RUSSELL CITY ENERGY CENTER
A joint development of Calpine and Bechtel

SUBJECT: RESPONSE TO ADDITIONAL CALIFORNIA ENERGY COMMISSION
STAFF DATA REQUESTS AND ADDITIONAL INFORMATION IN
SUPPORT OF THE APPLICATION FOR CERTIFICATION
RUSSELL CITY ENERGY CENTER (01-AFC-07)

01-AFC-07

Figure DR228-1
NEW POWER POLE LOCATIONS

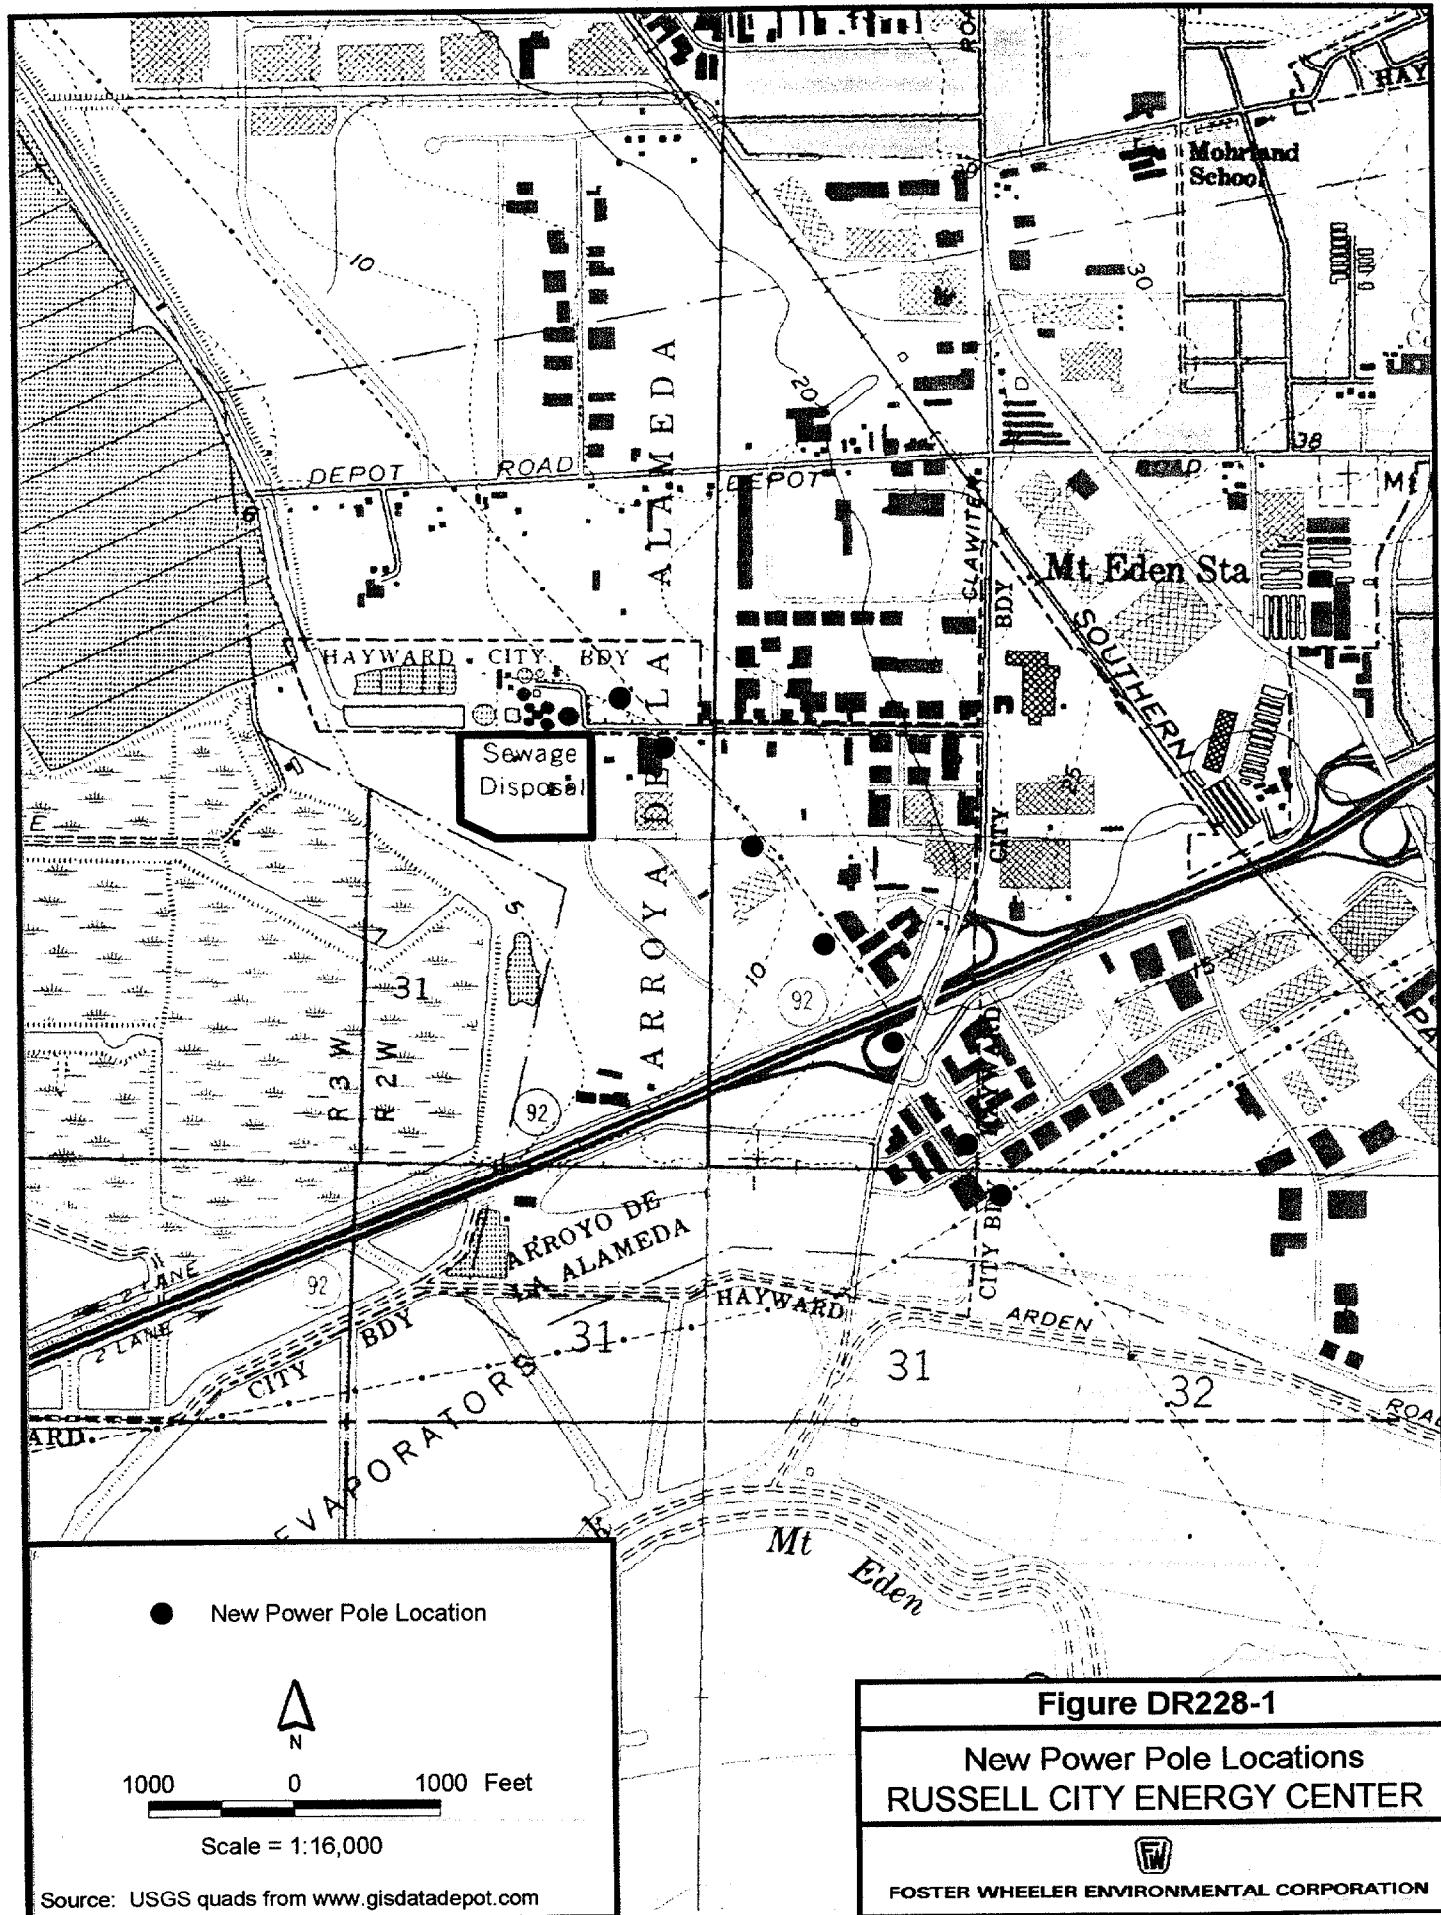
228 (2). How many new power poles will be added to support the new transmission line? Please verify that the base diameter of the steel poles will be approximately four feet and provide the

conductor size. Please provide a map indicating the locations of the new poles and approximate distance to other lines in the corridor.

Response: Seven new power poles will be added, including the turning poles at each end of the RCEC transmission corridor. The diameter of the poles is 4 feet (please see Figure AI195-1 in the Additional Information submittal of August 28, 2001). Conductor size will be either 954 kcmil SSAC or 1113 kcmil SSAC. Please see Figure DR228-1 (attached), a map showing the power pole locations.
